Intel[®] Pentium[®] II Xeon[™] Processor Specification Update

Release Date: November 2001

Order Number: 243776-031

The Pentium[®] II Xeon processor may contain design defects or errors known as errata that may cause the product to deviate from published specifications. Current characterized errata are documented in this Specification Update.

D30. Thermal Sensor May Assert SMBALERT# Incorrectly

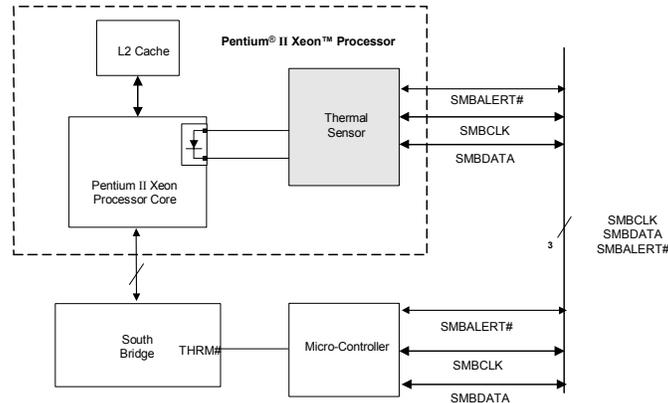
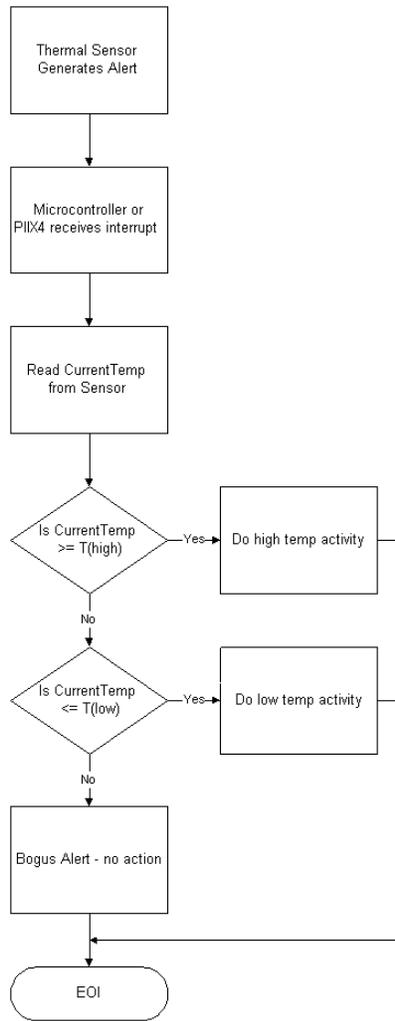
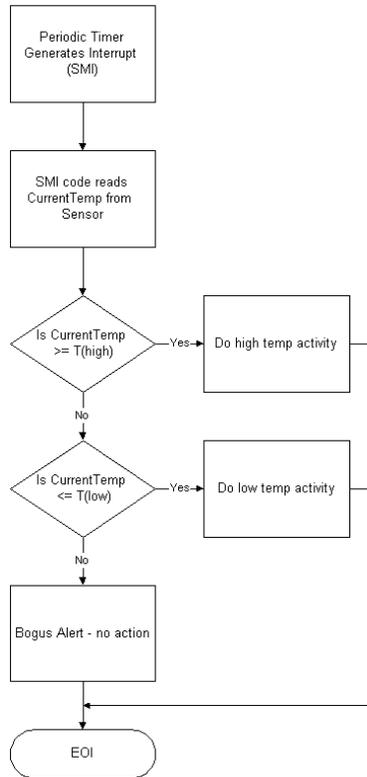
Problem: The Pentium II Xeon processor has a thermal sensor that monitors the processor core's temperature. The thermal sensor asserts SMBALERT# if the processor temperature exceeds the temperature limits set in the Alarm Threshold Registers (T_{HIGH} , T_{LOW}). It also sets the corresponding Status Register bits to identify the cause of the interrupt. Figure 1 gives one example of the how the SMBALERT# signal could be used in a system.

Under the conditions described below, the thermal sensor incorrectly generates the SMBALERT# interrupt. All of the following conditions must be met to trigger a false interrupt:

Workaround: Three different (mutually exclusive) workarounds are possible:

1. Before servicing an interrupt from the thermal sensor, read and compare the processor thermal reading with the threshold limits (T_{HIGH} or T_{LOW}). Figures 2 and 3 provide basic flowcharts for the implementation of this workaround in an interrupt driven system.
2. If the firmware implemented polls the Status Register only, then before taking any action, re-read the temperature register and do a comparison with the alarm threshold limits (T_{HIGH} or T_{LOW}) to determine if the value is actually still within the temperature window.
3. Use a temperature polling scheme to monitor the processor temperature
